DART SERVICE INSTRUCTION

TO AMEND INSTALLATION INSTRUCTIONS D206-642 REV. L AND INSTRUCTIONS FOR CONTINUED AIRWORTHINESS ICA-D206-642 REV. 1

REF. FAA STC: SA00475SE
REF. CANADIAN STC: SH98-4
REF. EASA STC: EASA.IM.R.S.01320

The D206-642-113/-114/-215/-216/-217/-218 Skidtube Installations and D206-642-149/-249 Run-on Wearplate Kits are added to installation instructions D206-642 Rev. L.

FIGURE 1: D206-642-113/-114/-215/-216/-217/-218 SKIDTUBE INSTALLATIONS

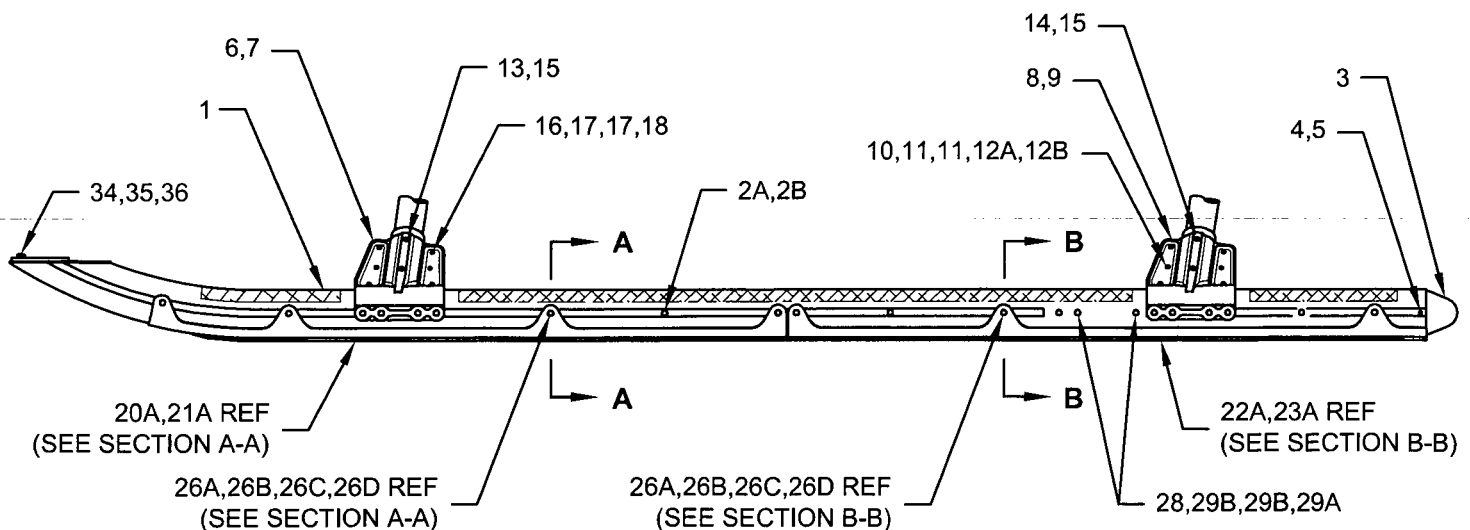
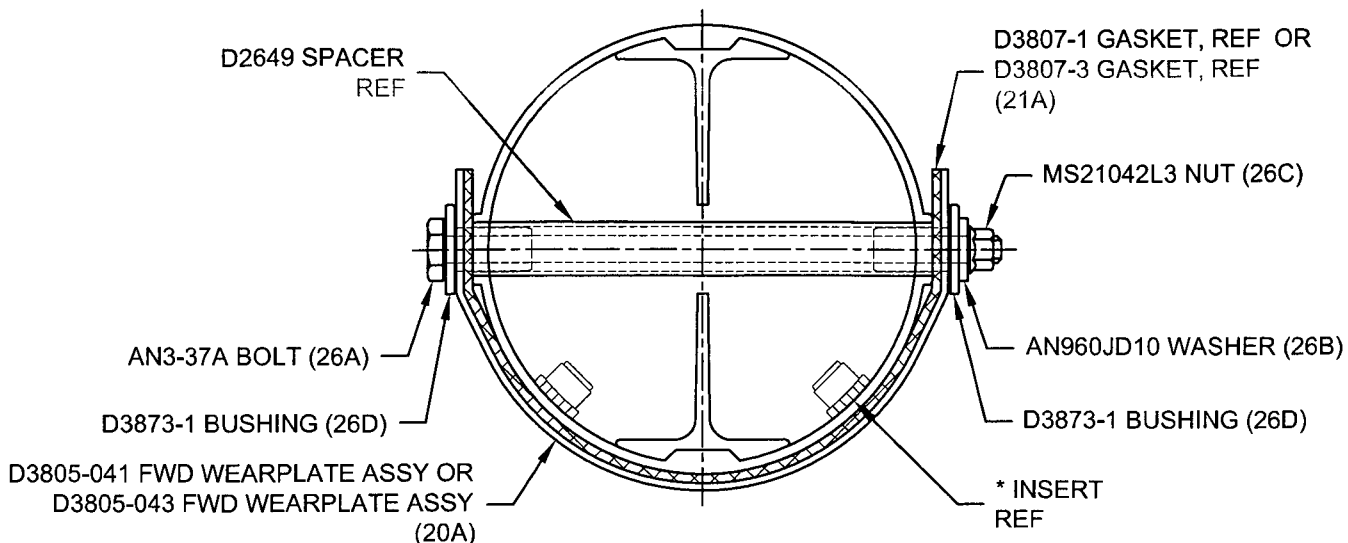
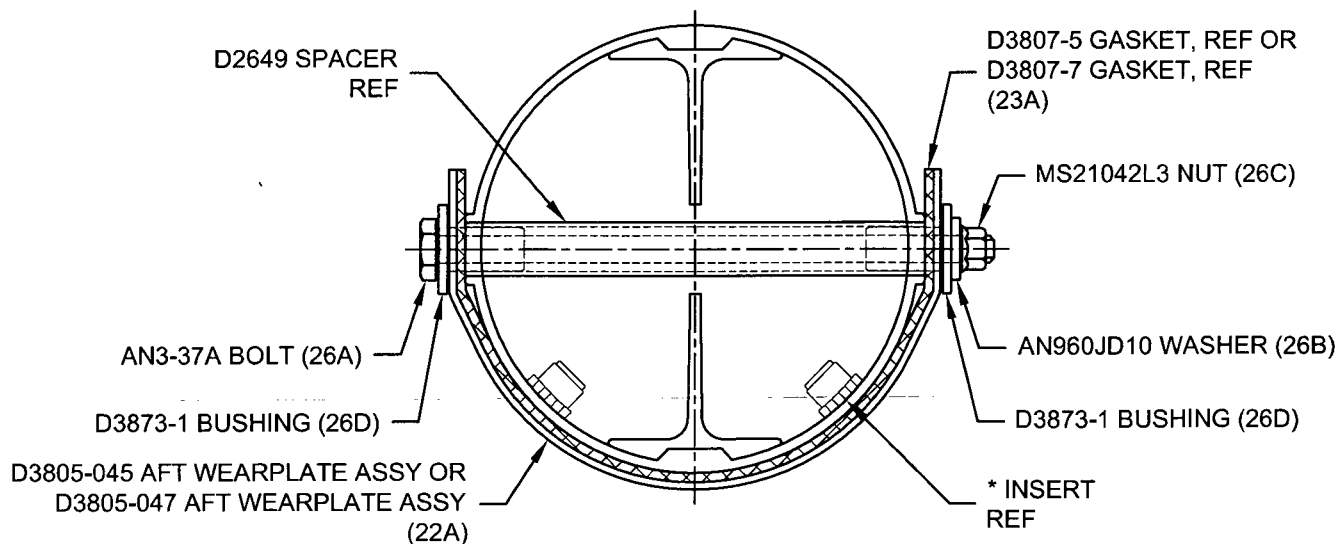
- 9.0.2 Remove qty(10) D2651-1 Plugs where the AN3 Bolts will be inserted to install the run-on landing wearplate assemblies. Refer to Figure 2.
- 9.0.3 Locate and temporarily install the Wearplate Assemblies per Figure 1. On both sides of the skidtube, transfer drill qty(2) Ø0.375" holes from the Wearplate Assembly to the Skidtubes as shown in Figure 2. Countersink the holes on both sides to Ø0.450" X 45°. Deburr.

- 9.0.5 Install the D3805-XXX Wearplate Assemblies using the qty(7) AN3-37A bolts and associated fasteners, as shown in Figure 1 of this service instruction. Torque fasteners to 15-25 in-lb (1.7-2.8 N-m).
